SMITTYBILT TECHNICAL UPDATE

SM-08.26.2015

APPLICATION JK 2 & 4 Door

PART NO. S/B76857

Fig A

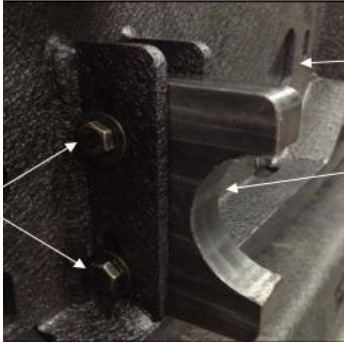
Possible excessive movement or rattling (Gen 2 tire carrier) part# 76857. This could be caused by the heim joint being too long and incorrect heim joint bolts. The tire carrier must rest in the "C" bump stop properly to prevent movement. (Fig A,B)

- A. You can remove one of the ends and cut off 1/4" of threading and re-insert. (Fig C)
- B. We will have inventory of the shorter Heim joint (Part # 76857-03) ETA 8/27 and more coming 9/4

- A. We have larger diameter shoulder bolts (Part #76857-02) instead of the fully threaded 12mm bolts included. ETA 8/27 and more arriving on 9/2

Future shipments of the 76857 will have the shorter heim joints and shoulder bolts. ETA 10/29.

Fig C

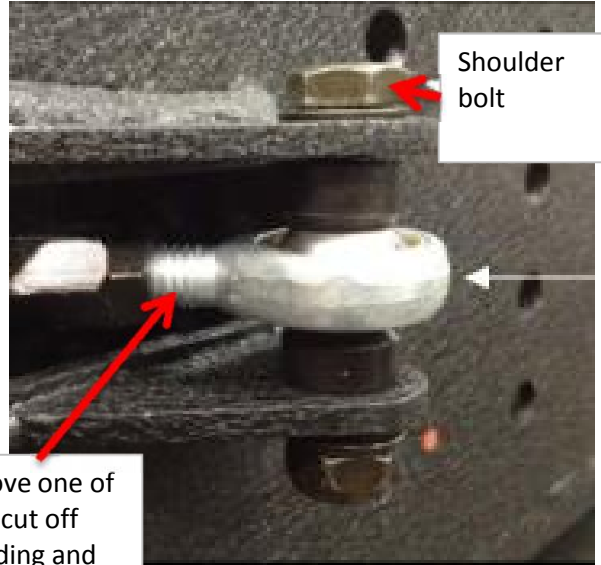
You can remove one of
the ends and cut off
1/4" of threading and
